2-SG-07-C/2-G-07-UR
 CONCEPT PLAN/USE ON REVIEW

Detached residential subdivision in PR (Planned Residential)

Petitioner: Cagle Property Subdivision
 Sundown Properties

CONCEPT GRADING AND DRAINAGE PLAN
 CAGLE PROPERTY
 CORNER 8100 ROAD
 KNOX COUNTY, TENNESSEE

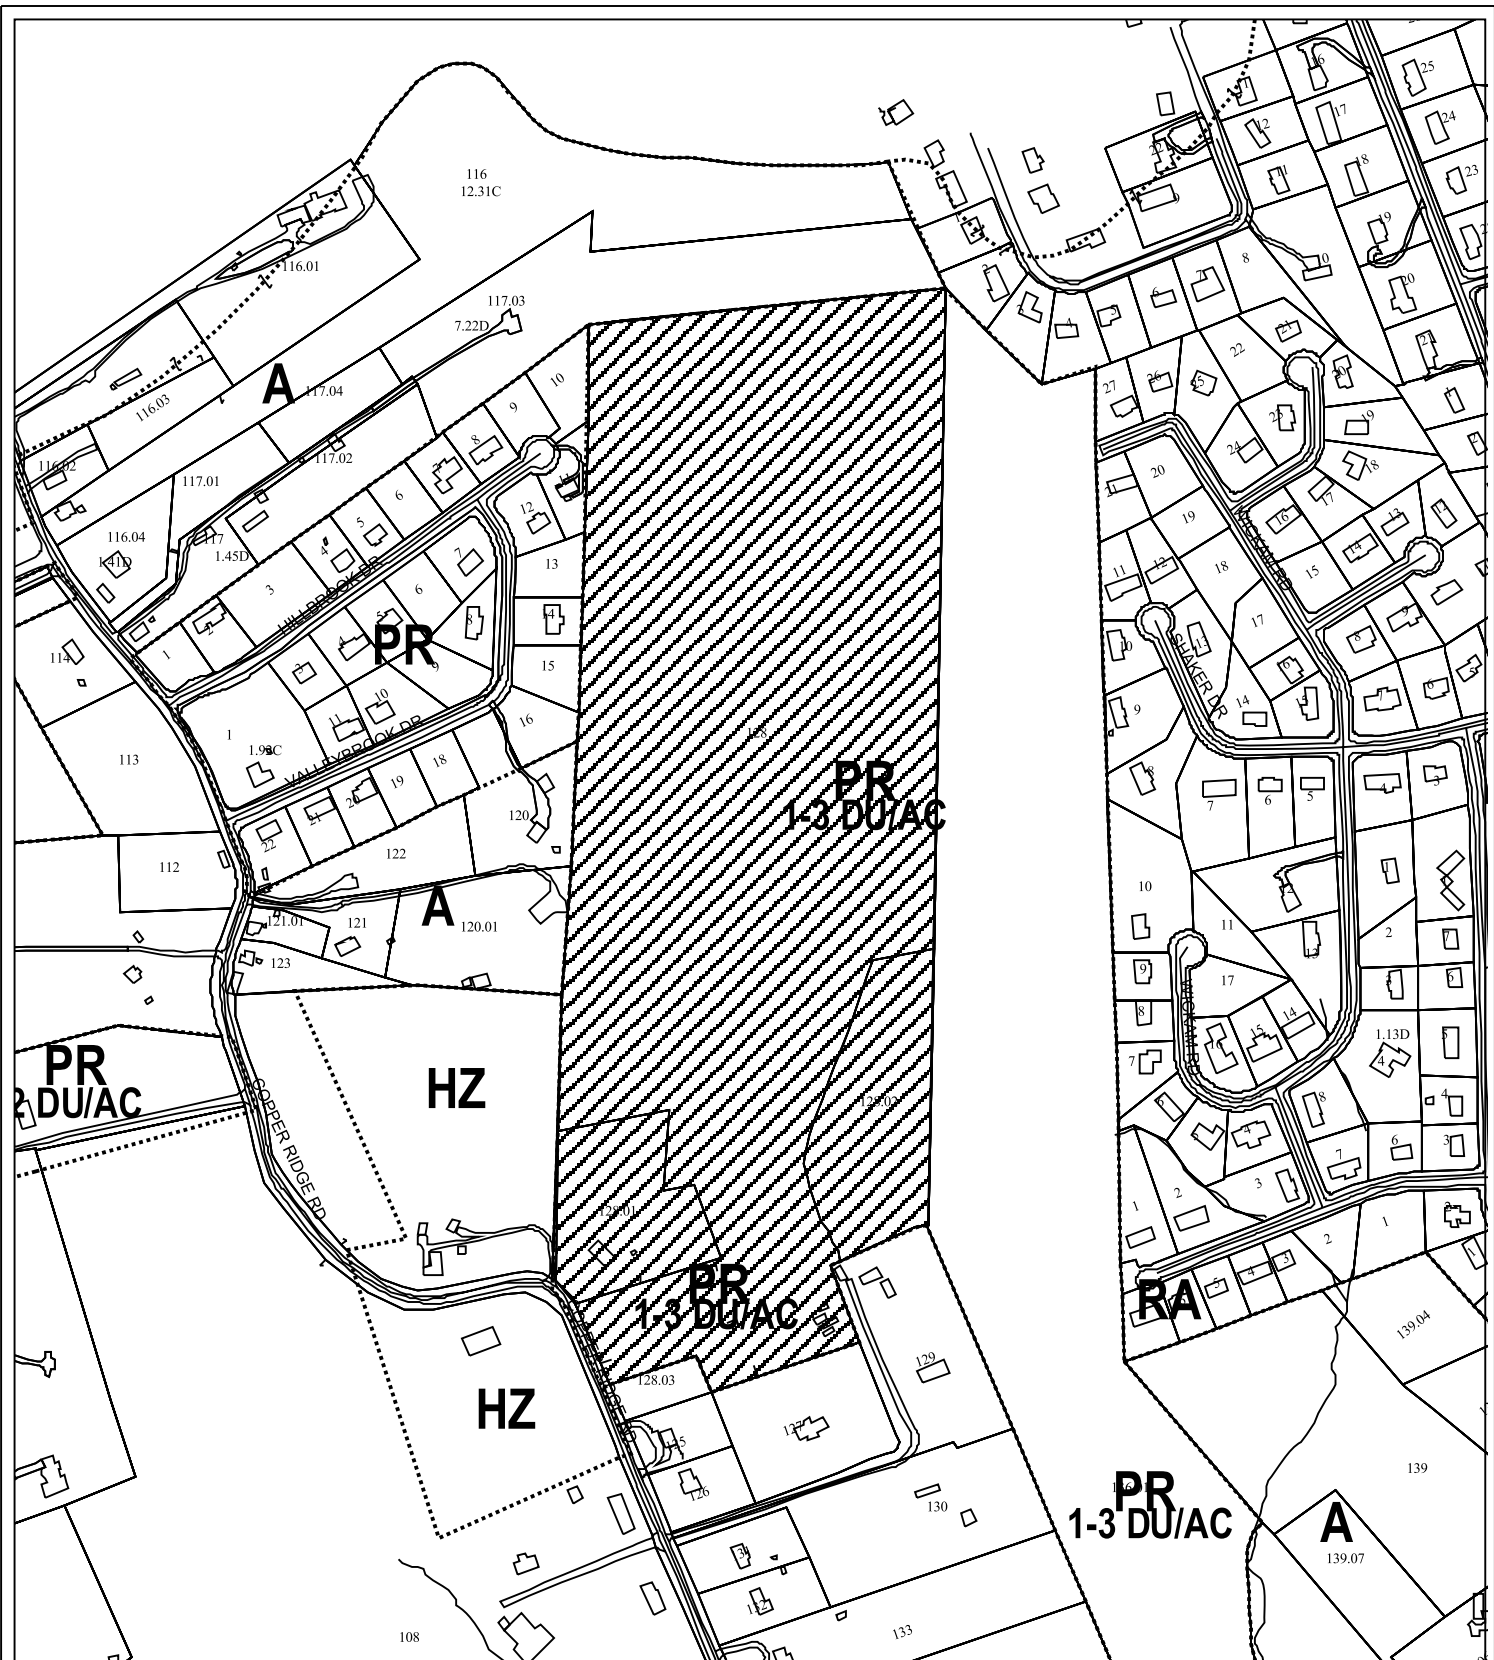
3. Placing a note on the final plat that all structures will have to be located at least 50' from the top of the sinkholes/closed contour areas identified on the plat. Construction within the 50' setback may be permitted if a geotechnical study prepared by a registered engineer states that building within the 50' sinkhole buffer is acceptable and the study is approved by the Knox County Department of Engineering and Public Works. Engineered footings may be required for any structures within the 50' sinkhole buffer.

4. Combining Lots 58 and 113 with the adjoining lots since building sites do not exist on those lots outside of the sinkholes/closed contour areas.
5. Meeting all applicable requirements and obtaining all required permits from the Tennessee Department of Environment and Conservation for any alteration to the sinkholes.

8. Revising the concept plan to show how legal access is provided to Tax Parcel 077 12804. It appears that this lot was subdivided on November 29, 2006 by deed only and did not go through the platting process as required. It needs to be determined if access should be provided to Road A.

There are four sinkholes/closed contour areas located on this property. The sinkholes and a 50' building setback from the top of the sinkholes/ closed contour areas shall be designated on the final plat. All lots in the area of these features must have a suitable building area outside of the setback area. An option would be to have a geotechnical study conducted by a registered engineer that would identify that building within the 50' building setback area is acceptable, and the study is approved by the Knox County Department of Engineering and Public Works. Engineered footings may be required for any structures within the 50' sinkhole buffer.

Since building sites do not exist on Lots 58 and 113 outside of the closed contours the two lots need to be combined with the adjoining lots.
